FMTV...

# Get Upgraded M777 Howitzer Latch Kit

Instructions and the items to the right come in the RK-775 kit:

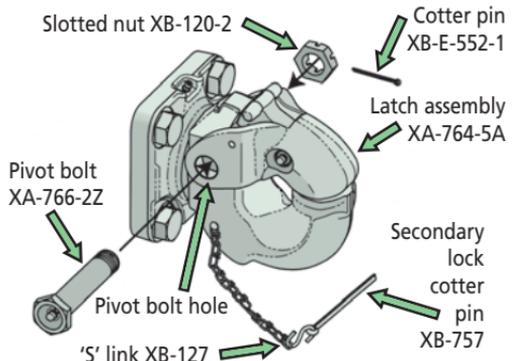
But chances that this separation could happen are increasing with older versions of the M1083 or M1093 pintle hooks that use a staked latch pin assembly. You can identify these old-style pintles by the four staking marks on each side of the latch pin. They make sure the pins stay in the latch assembly.

Prevent separation while towing by getting the upgraded pintle latch kit. This new RK-775 latch kit, NSN 2540-01-579-6710, replaces the upper pintle hook latch assembly with a non-staked, positive retention assembly.

Not shown:	
Never-Seez®	XB-02967
2 Zerk fitting caps	XB-767-10
